ISSUE: Permit to Demolish/Capsulate (partial) and Certificate of Appropriateness for (alterations, addition)

APPLICANT: Christopher & Sarah Miller

LOCATION: Old and Historic Alexandria District
826 South Lee Street

STAFF RECOMMENDATION

Figure 3: Comparison of existing and proposed east elevation

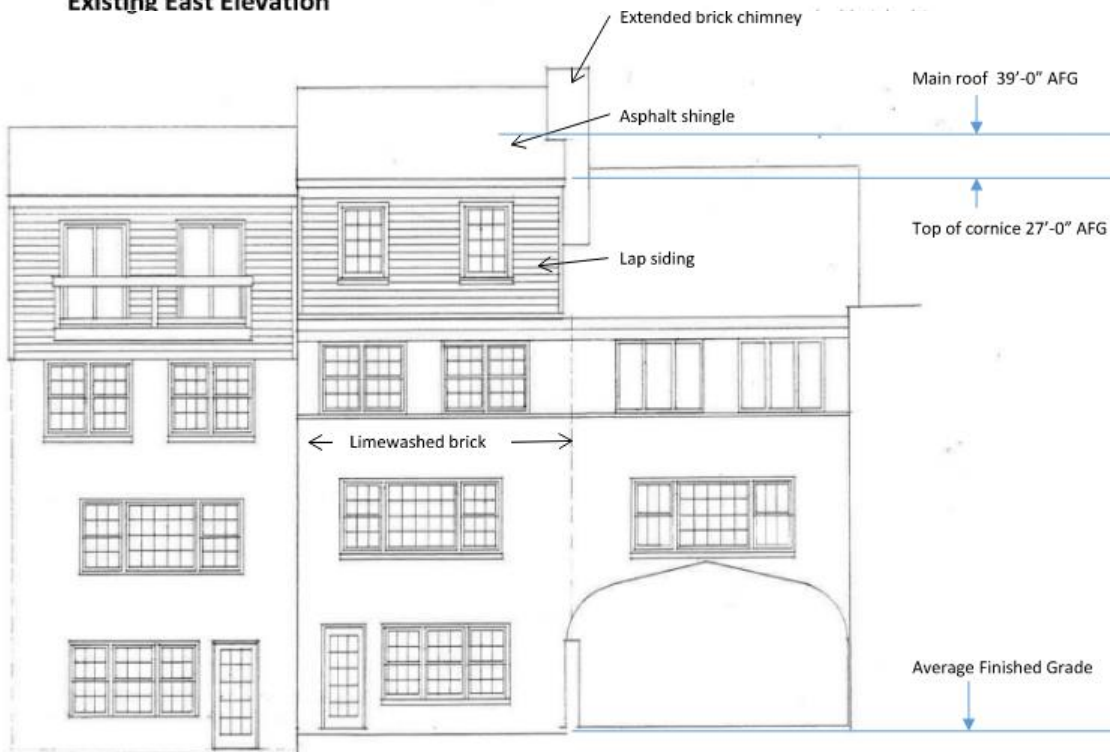
The applicant is proposing an asymmetrical gable roof configuration with the front slope meant to be similar and complementary to other roofs in the vicinity. The use of a lower slope roof for the rear part of the structure allows for the creation of usable space that is shifted away from the primary elevation. At the east elevation, this creates a vertical addition to the existing wall. The applicant is proposing to clad this addition in fiber cement siding and use two simple casement style windows centered on windows below. According to the *Design Guidelines*, “An addition to a historic building should be clearly distinguishable from the original structure. An addition should not obscure or dilute the architectural and historic importance of an existing building by creating a false sense of the past. To create a differentiation between the existing building and an addition, different traditional materials can be utilized.” The east side of the building is clearly a secondary elevation and only visible from the public park and not a street or sidewalk. The use of fiber cement on the east elevation of the addition clearly distinguishes it from the existing building while taking design cues such as the window spacing from the existing building. Figures 2 and 3 below show the existing and proposed east and west elevations.

Upon the removal of the existing parapet on the west elevation, the applicant is proposing a new cornice at the base of the new sloped roof. This cornice will be in addition to the decorative trim to remain in place, similar to adjacent buildings. This simple cornice is clearly different than the existing to remain and is an appropriate termination for the sloped roof. There are little details provided regarding the details of this trim, so staff recommends that the applicant work with staff on these final details as the project moves to the construction drawing phase.

The applicant is proposing to use a lime wash on the brick at the exterior of the east and west sides of the existing building. Limewash is a process by which a translucent white finish is applied to an existing brick surface. Unlike paint, which can trap moisture and potentially damage brick and mortar, limewash is similarly porous, allowing moisture to pass through the finish. As the finish is translucent, the character of the existing brick is allowed to come through the finish and variations in color and brick patterns are clearly read once the process is complete. The Board has approved the use of this finish on Later buildings throughout the district as a way to provide a new look for a mid-twentieth century brick building without completely obscuring the original design intent.

1. The windows comply with the *Alexandria New and Replacement Window Performance Specifications in the Historic Districts*
2. The applicant work with staff on the design for the trim at the new cornice on the west elevation.
